4.5 Cycle Facilities

4.6 Bloom Street - Roof Extension

5.0 Heritage Proposal

5.2 Altered Heritage Items

PROPOSED BIKE STORE

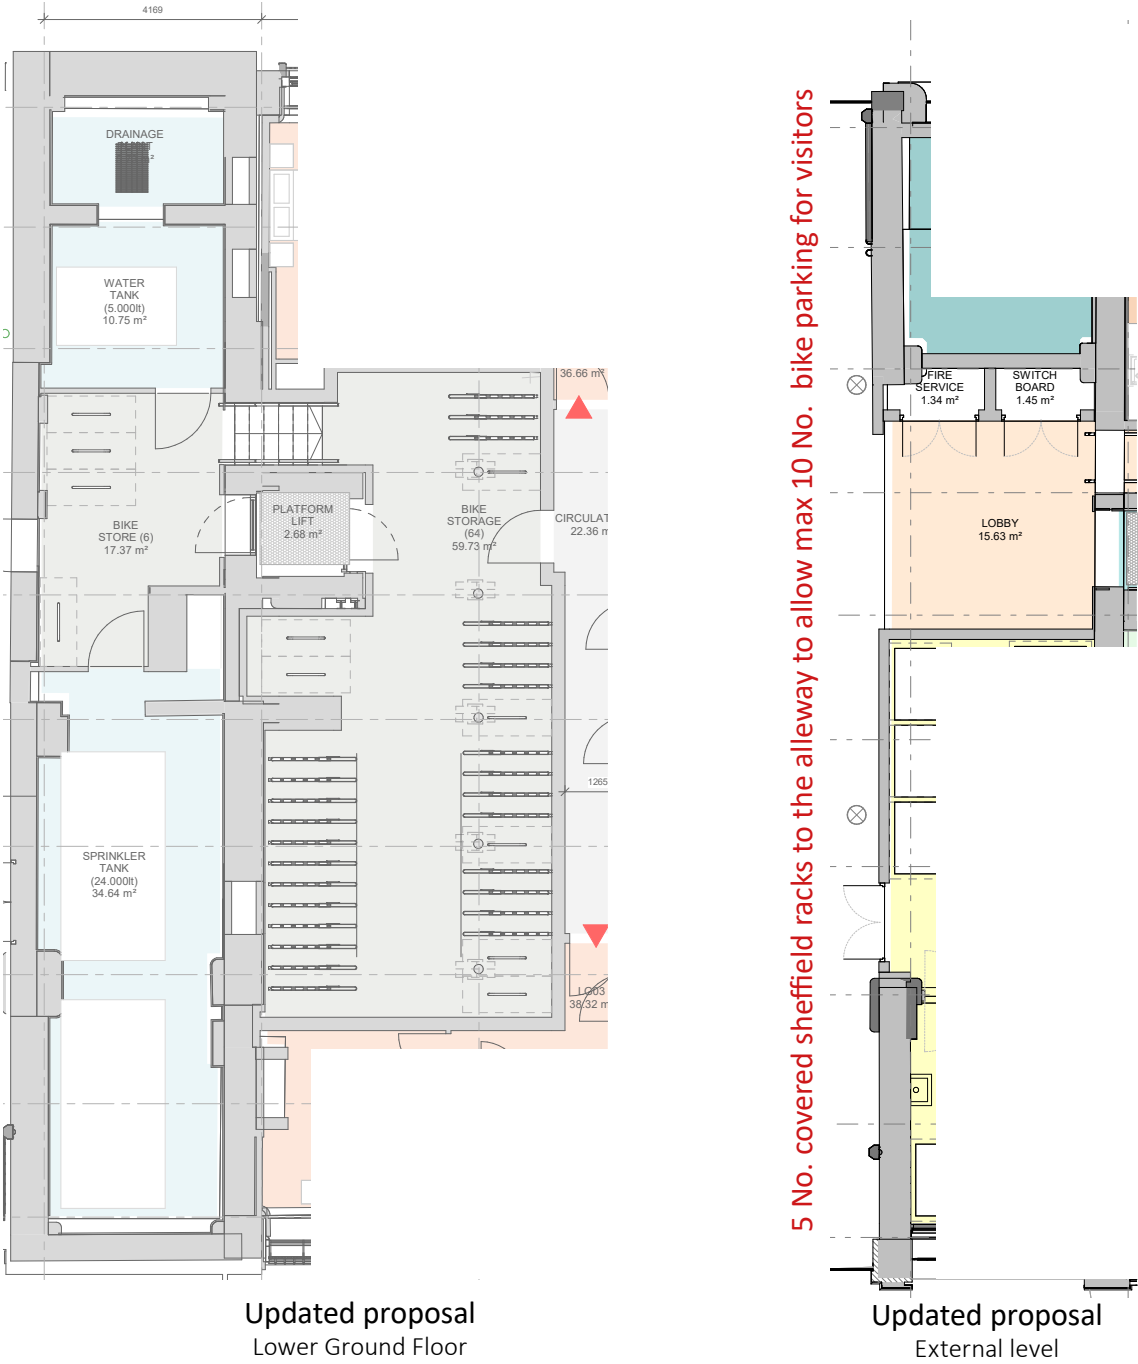
The current proposal includes 24 bike parking spaces at the entrance level and an additional 24 spaces on the lower ground in a double-stacking arrangement, totaling 48 spaces. However, the planning requirement stipulates one parking space per apartment, totaling 80 spaces, indicating a need for an additional 32 spaces.

In the approved proposal, the bike parking at the entrance level is situated within the accessible entrance, consequently downgrading it to a more utilitarian access rather than the inclusive entrance it should be.

The current proposal permits one bike parking space per apartment, for a total of 80. Of these, 76 are located in the lower ground floor and basement, both accessible via the platform lift. Further 4 spaces, secured through 2 sheffield racks, are located in the alleyway for visitors or temporary parking.

Approved balconies now proposed to be removed

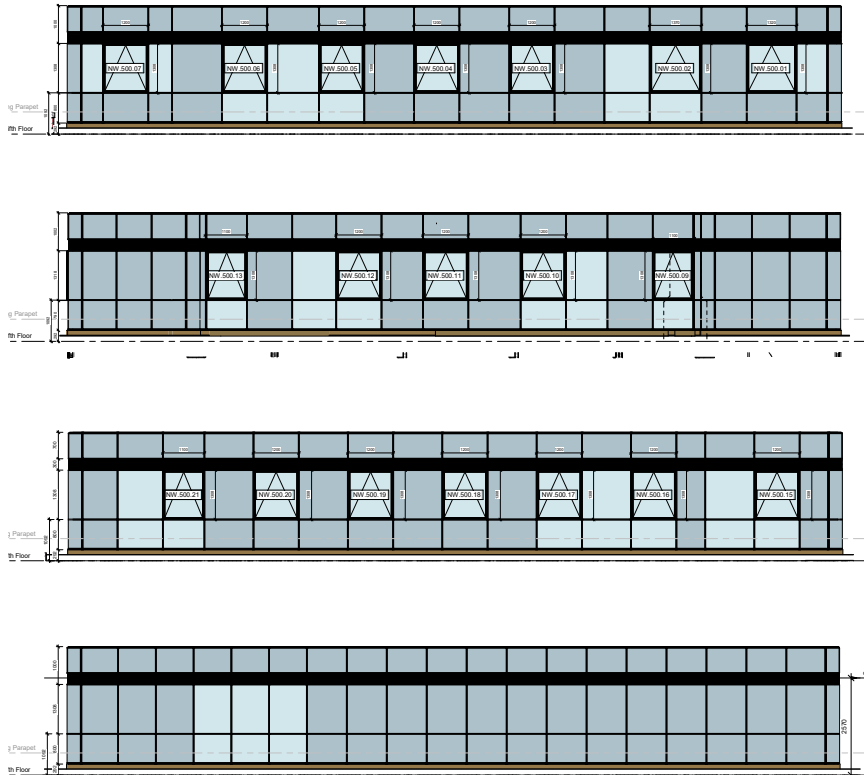
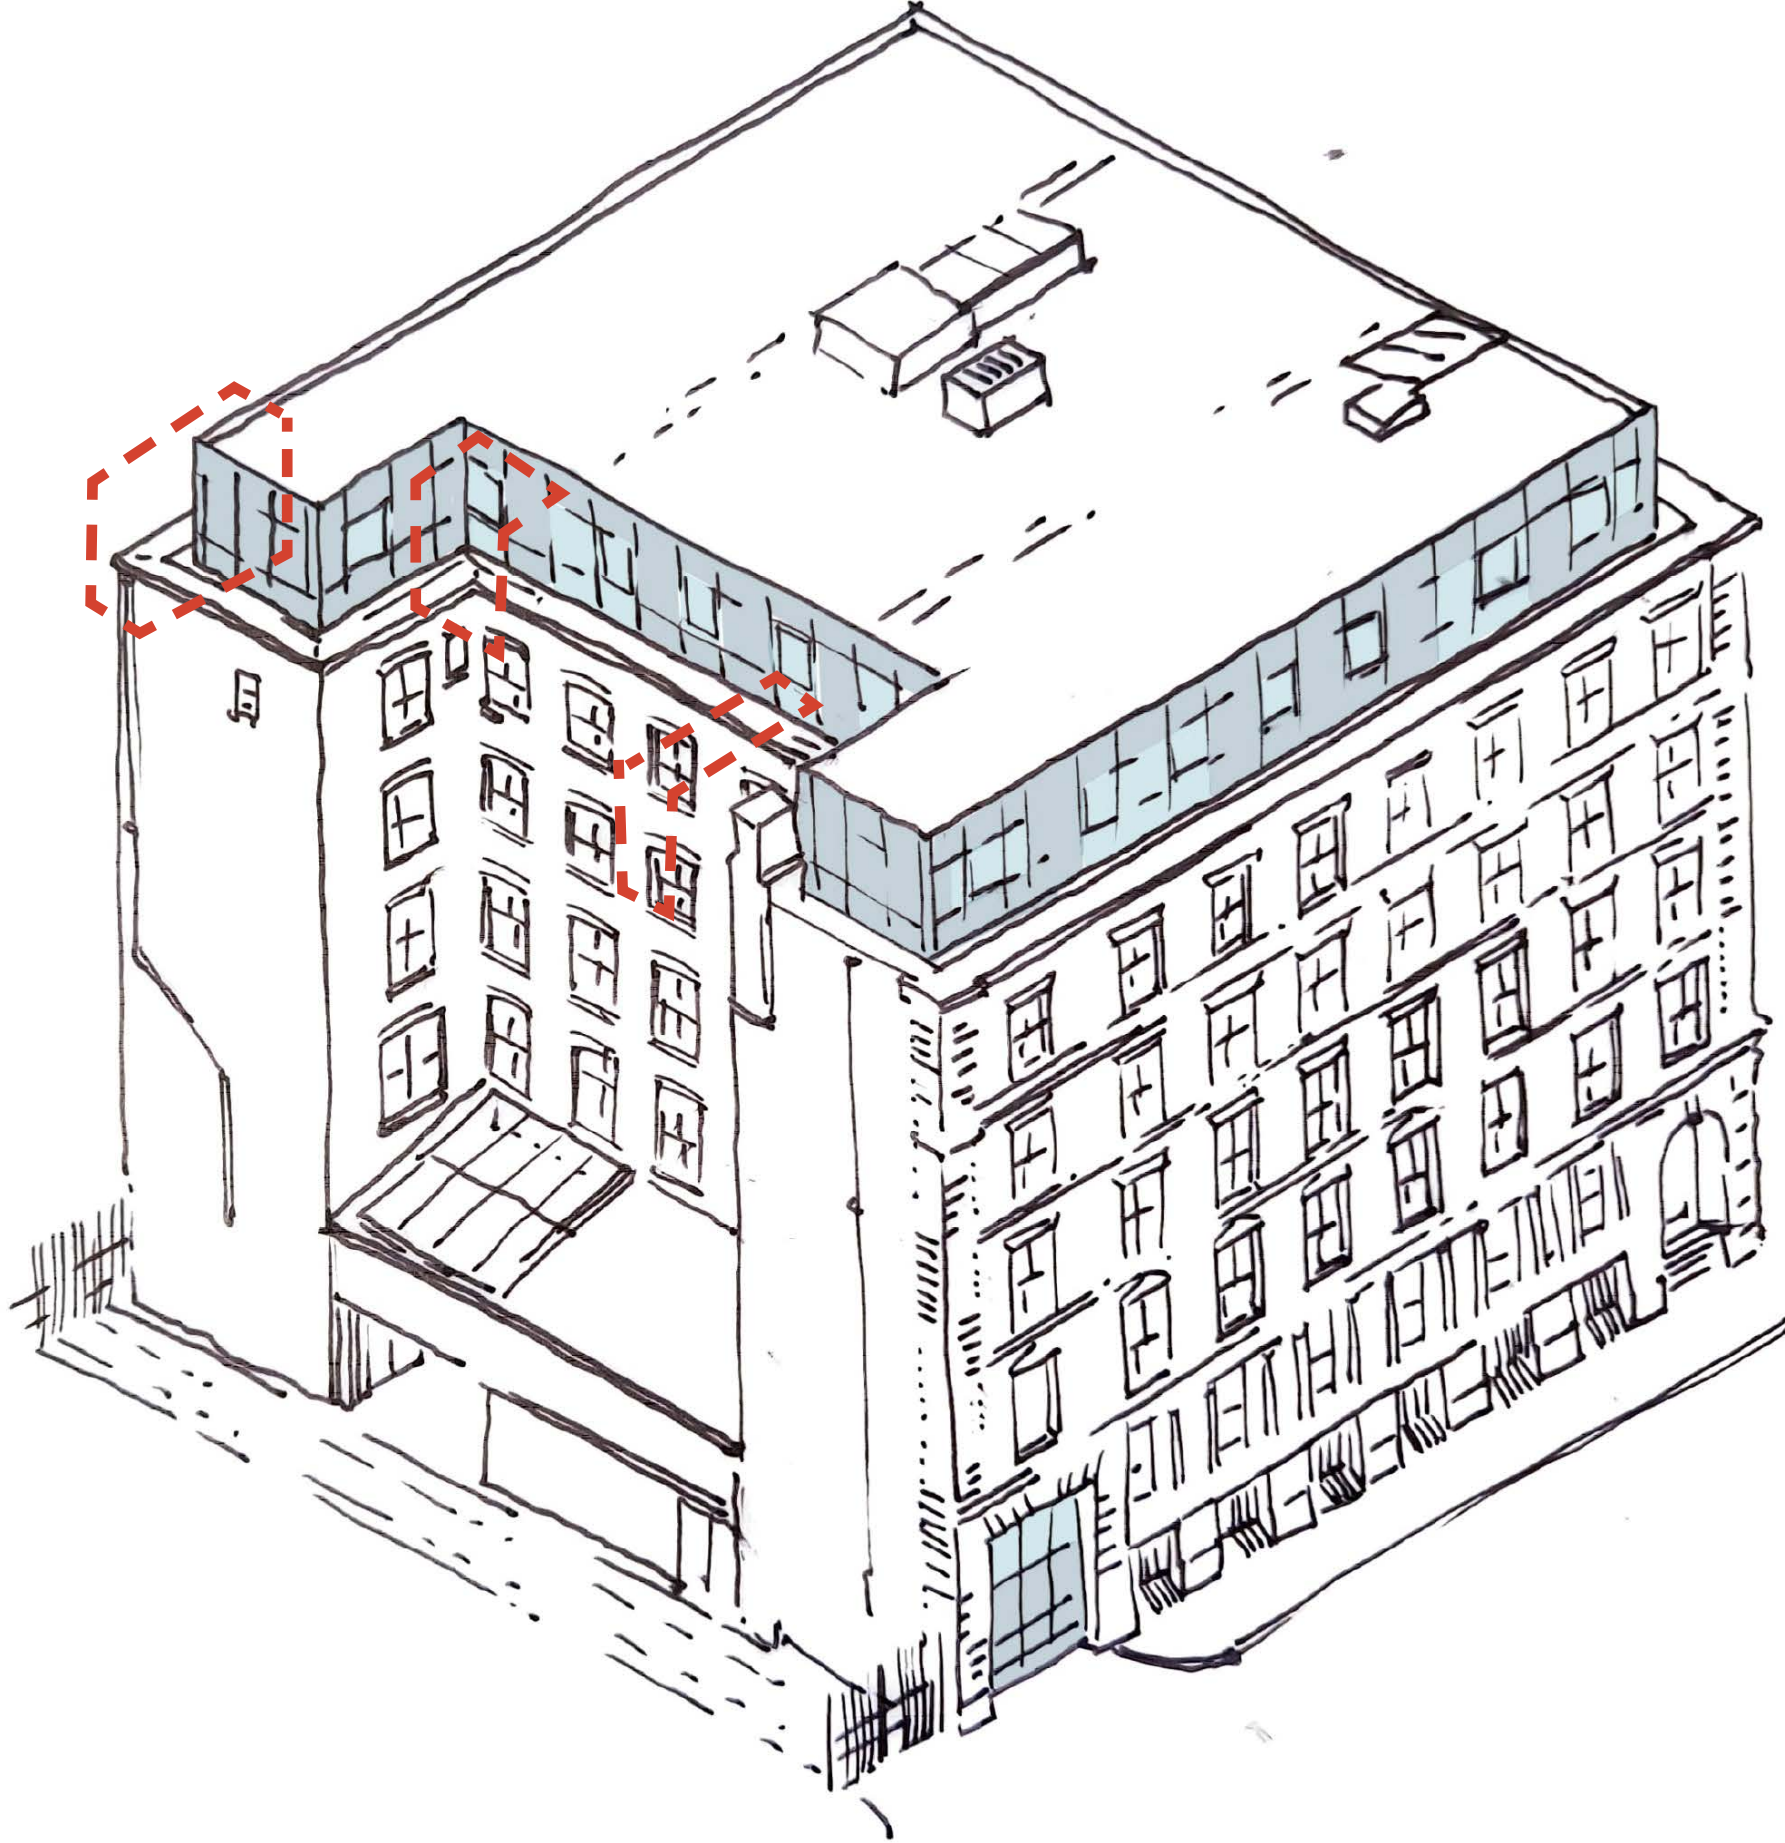
The previously approved scheme included a glazed extension atop the existing building, which is proposed to be retained. The proposal also incorporated three small balconies on the alleyway elevation. However, these balconies were found to be too small for practical use and detrimental to the layout of the adjacent apartments.

As part of the scheme review, it is now proposed to remove these balconies and reconfigure the space of the apartments. The overall aesthetic remains largely unchanged, with the only alteration being the removal of vertical glazed fins, resulting in a sleek glazed box that subtly enhances the existing structure.

- Central lift hoist

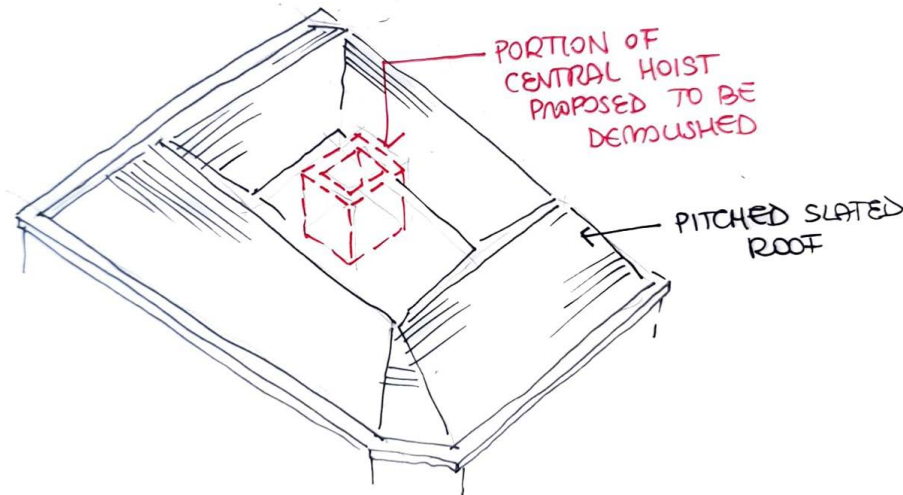
To help with the location of required plants within the central flat roof area, the portion of the masonry hoist extending above roof level is proposed to be demolished. The cut is proposed to be done just below roof level.

- Old sprinkler system

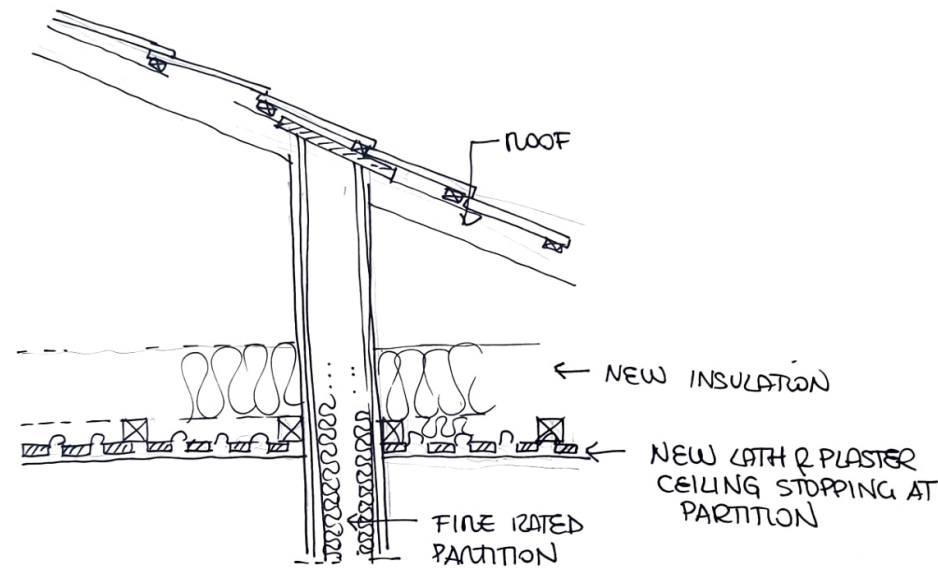
The communal pipes and valves are proposed to be retained, refurbished, and relocated as a feature. However, it has been observed that smaller elements of the system, such as the distribution pipes, have mostly been removed from the site, with only a small portion remaining. Those elements are in poor condition and are situated in locations that do not align with the fire strategy. Therefore, they are now proposed to be removed.

- Blind windows on Richmond St.

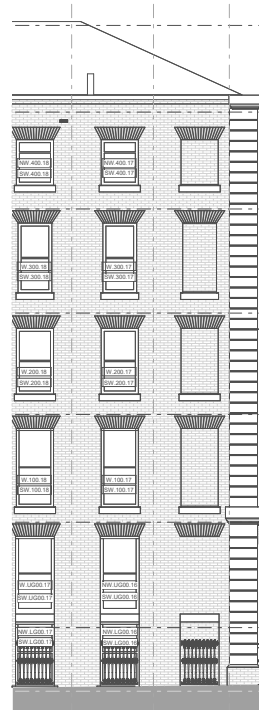
The line of blind windows on gridline M1, originally intended to be reopened, is now proposed to remain bricked off.

It has been determined that the bricked infill was part of the original design. Since there is no requirement for glazing in the proposed scheme, it is proposed to leave the windows as they currently exist.

- *Timber panels (lost)*

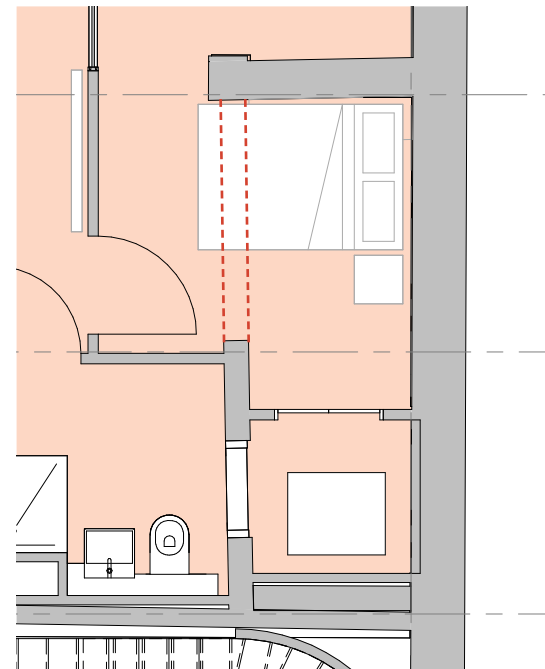
Previously, it was noted that there were missing timber panels in Mindel House, identified in the approved proposal to be preserved as heritage features within corridors.

Upon reviewing heritage records, it has become evident that the timber elements indicated in the drawings were originally part of timber partitions, as depicted in the photographic records above. Unfortunately, these elements are now lost. However, due to their combustibility, it would not have been feasible to place them along escape corridors as previously proposed.

- *Stone parapet lead*

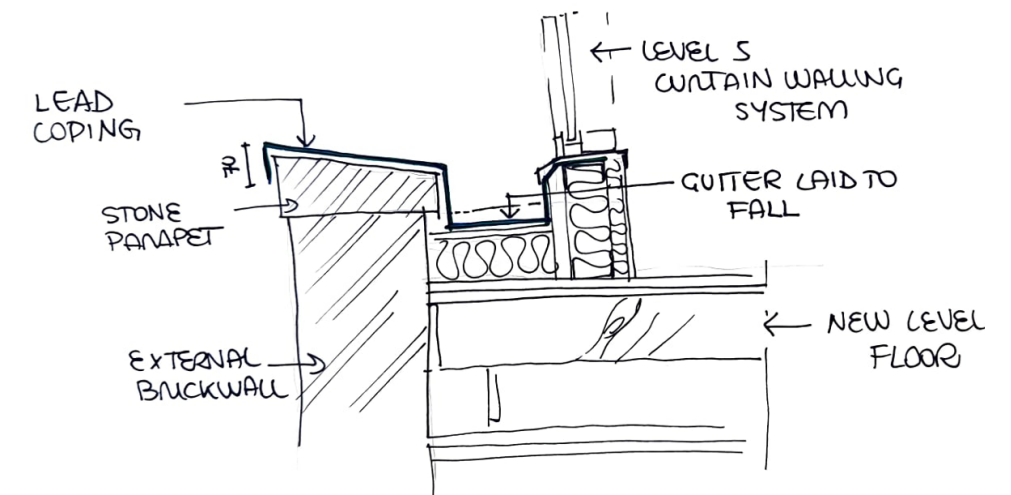
As per Mindel house, the stone parapet is proposed to be dressed with lead flashing to endure weather protection. The detail here is slightly different as it interfaces with a flat surface and the level 5 extension.
